**HP PERMIT NUMBER:** HP-0684-2025

**PROPERTY ADDRESS:** 1204 S Newport Ave

**DISTRICT:** TRACY PARK

**A. CASE ITEMS FOR CONSIDERATION**

Porch Column Options

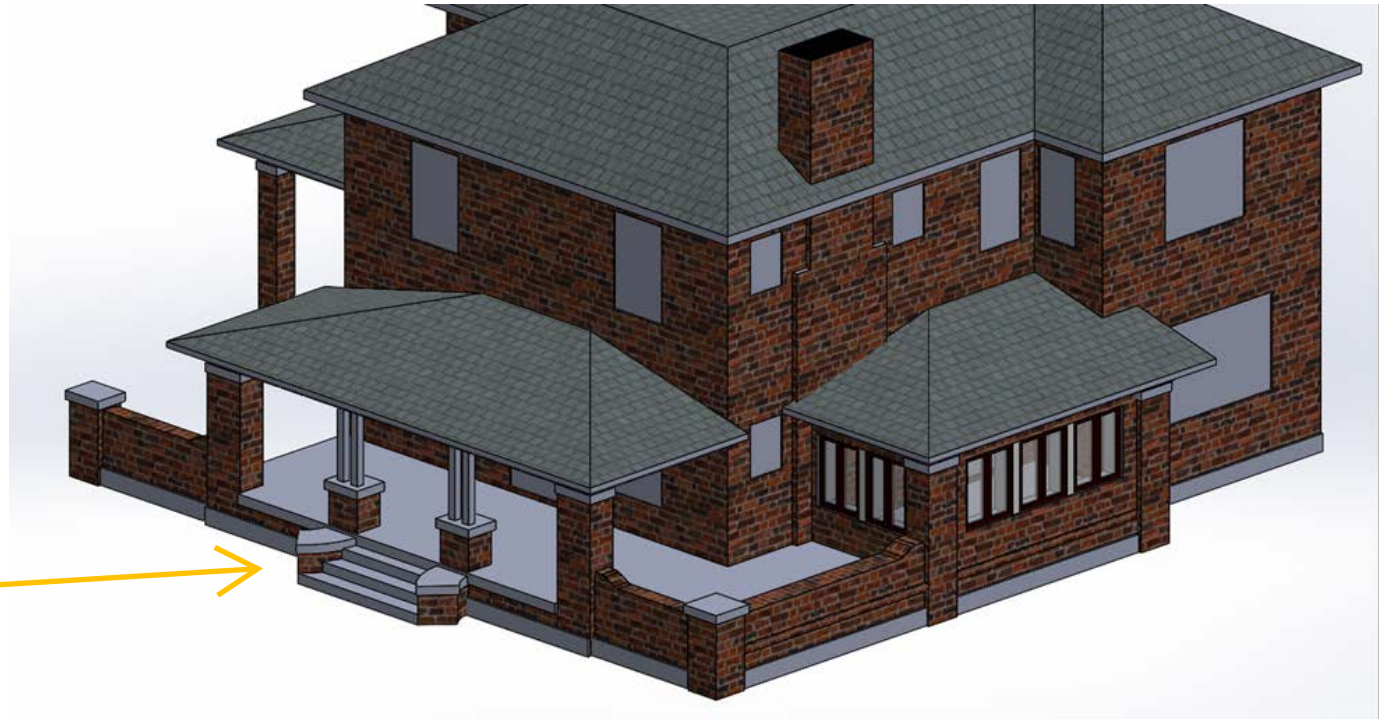
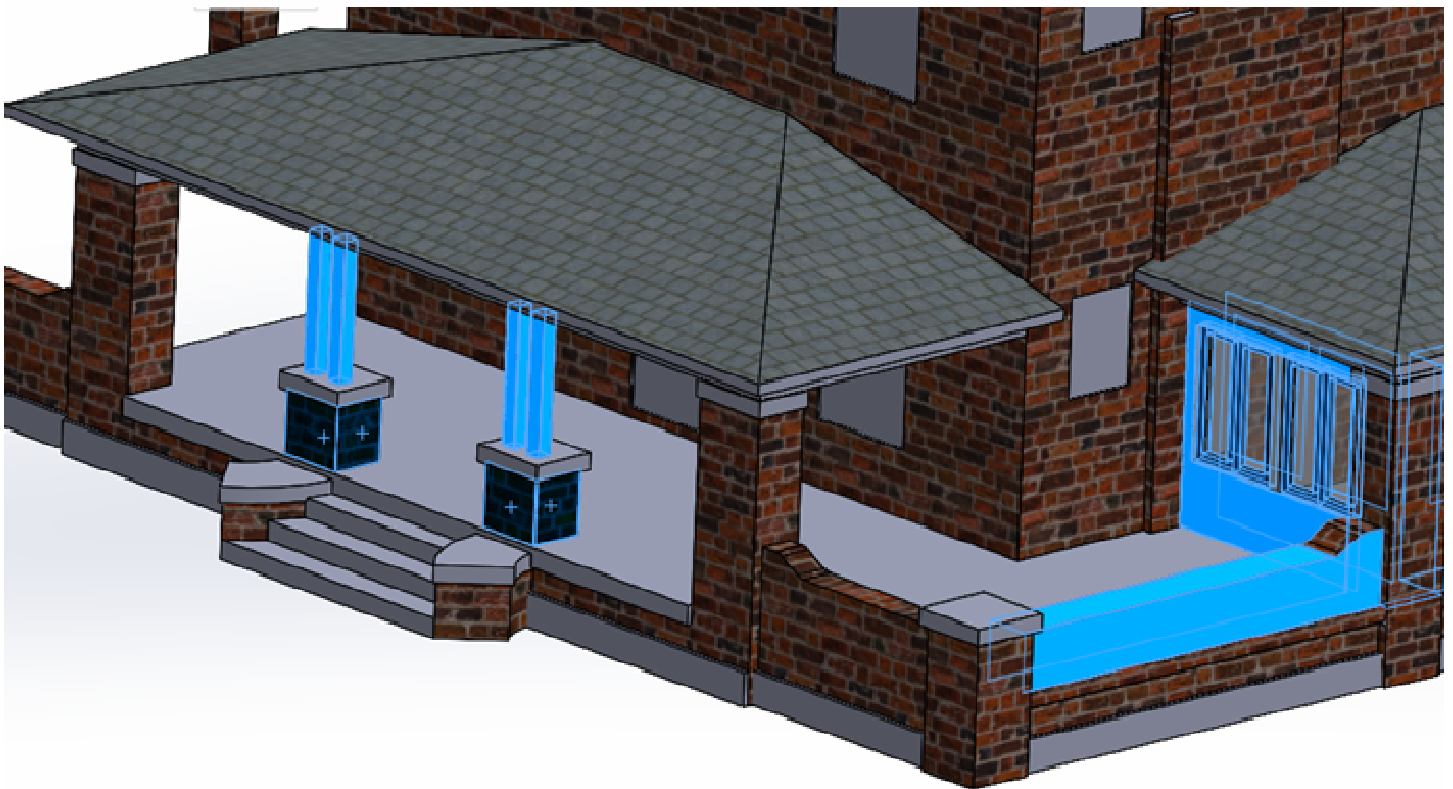
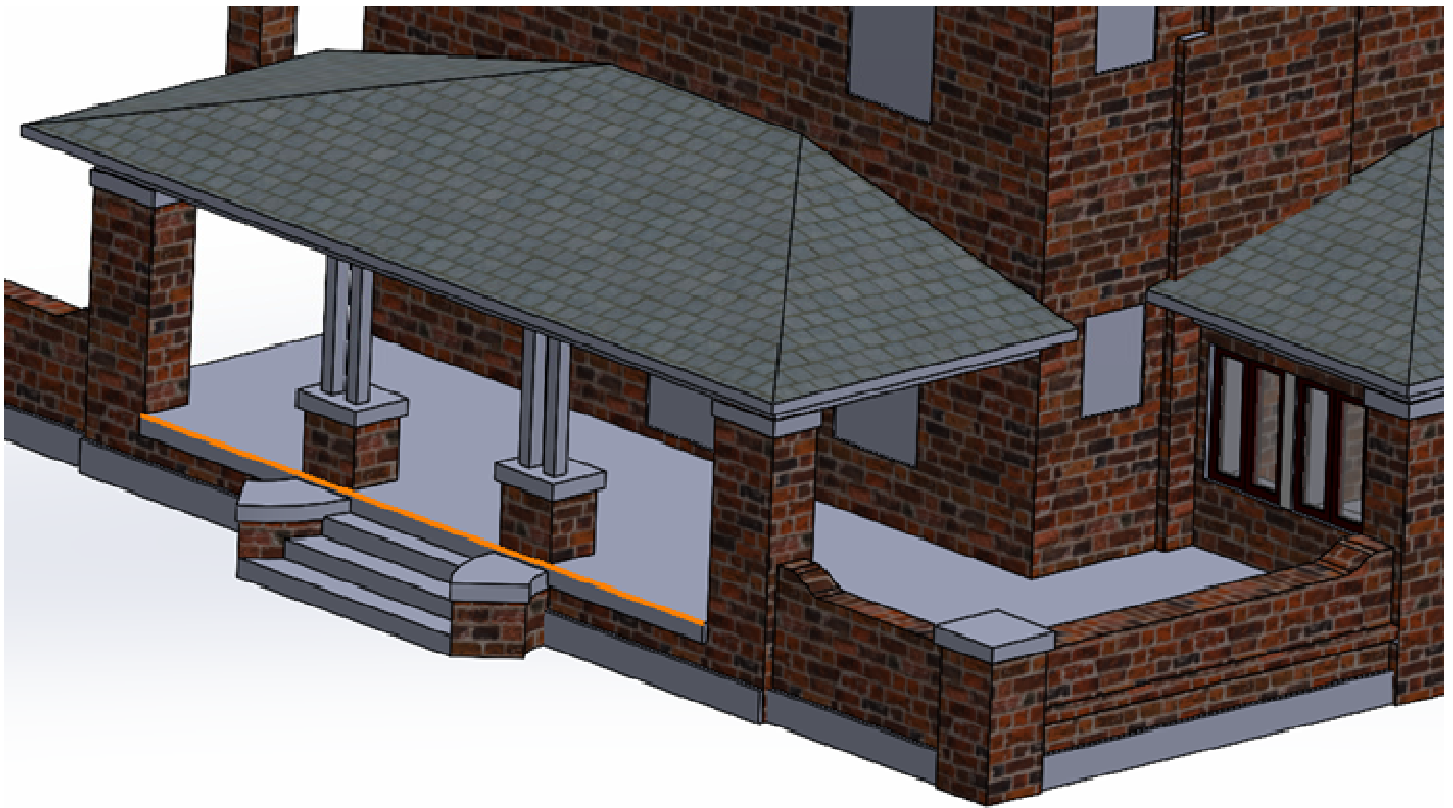
1. Staff have approved the in-kind the replacement of the concrete porch/patio floor and steps and while doing so the applicants would like to
  1. remove the existing wood porch columns on the front porch.

2. install two shorter new capped porch brick pillars with wood posts to coordinate with the existing tall brick porch columns.Additionally, staff have approved the removal of a non-historic section of roof and wall/siding that was previously enclosing the northeast portion of the porch/patio, and the applicants would like to continue their restoration of the porch by

At the July 10th, 2025, meeting, the subcommittee moved to forward proposal items 1 and 2 to the full Commission with no recommendation and asked the applicant to provide staff with neighborhood examples of similar columns and additional options for the Commission to consider.
